2015 NATIONAL STANDARD PLUMBING CODE ILLUSTRATED

ERRATA to the 2015 NSPC First Printing

April 15, 2015

Figure 7.10.6
A SHOWER PAN AND DRAIN

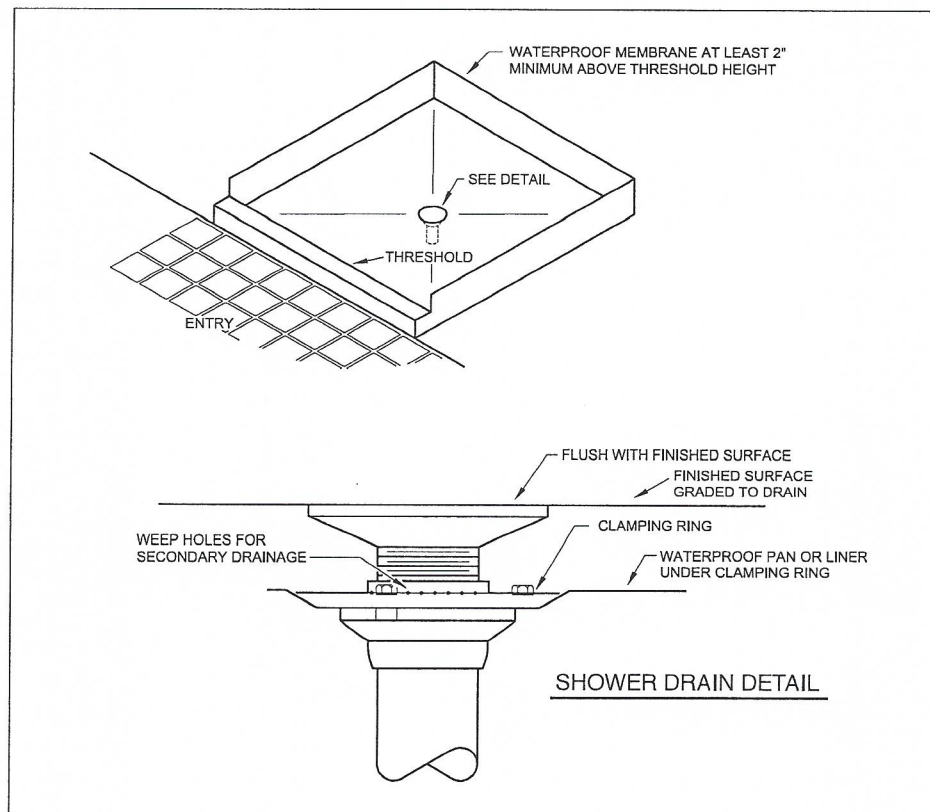
Page 180, Section 7.10.6: Item "f" was removed in error and has been re-inserted in the Second Printing.

Insert 2012 NSPC version of item "f" as follows:

Change the 2015 NSPC First Printing item "f" to item "g".

f. Shower pan liners shall slope to the shower drain outlet and be sealed to the weep holes in the drain fitting. The liner shall provide a water-tight basin up to the overflow elevation of the shower floor.

g. Shower pan liners shall be tested for leakage. There shall be no leakage indicated on the floor surrounding the shower pan for a period of not less than 15 minutes.
